**ADDENDUM #1**  
**BID #1718-19, Anaheim Campus 2nd Floor Counseling Offices & 5th Floor CTE**  
**Lab Tenant Improvements**

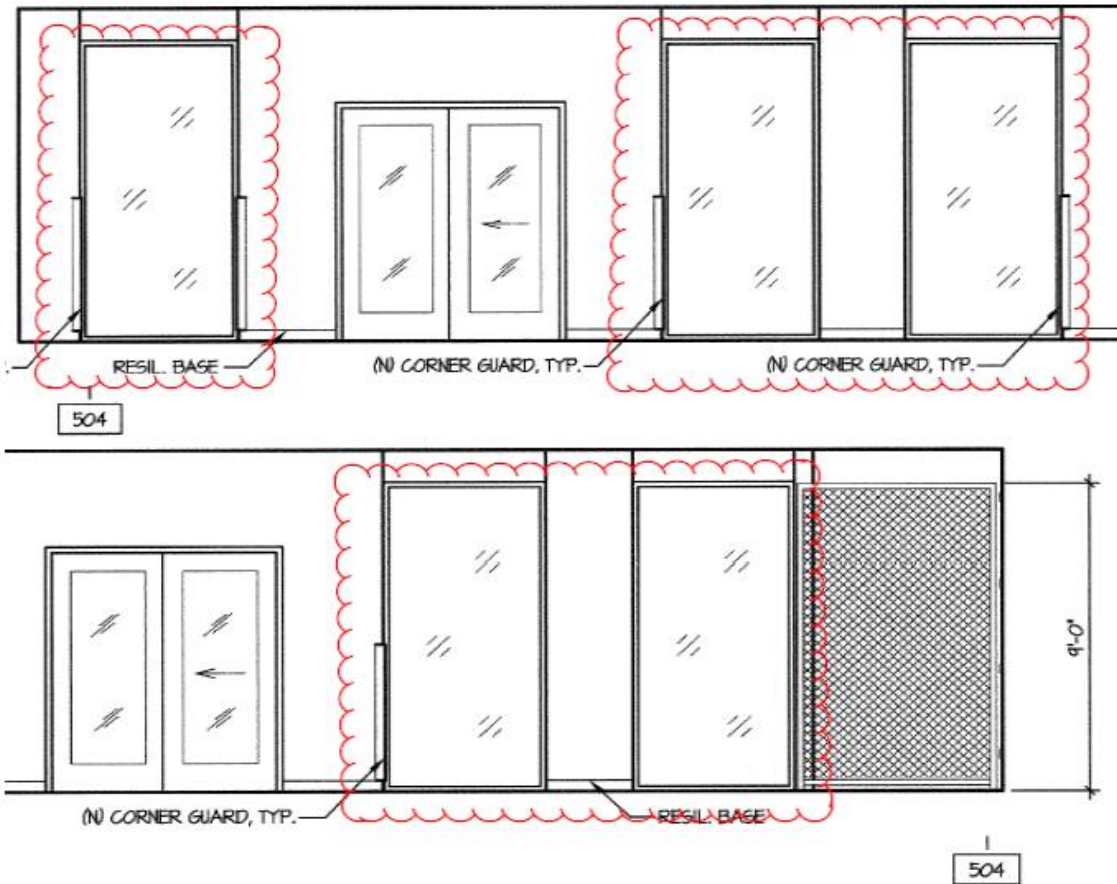
**A. All new partitions at rooms 504A & 504B are in the contractor' scope of work for this project.**
6. Please verify whether the glass openings shown in the elevation view of section 1/504 on sheet A/A5-04 are existing or new.

**A. The clouded windows on the sketch below are existing.**
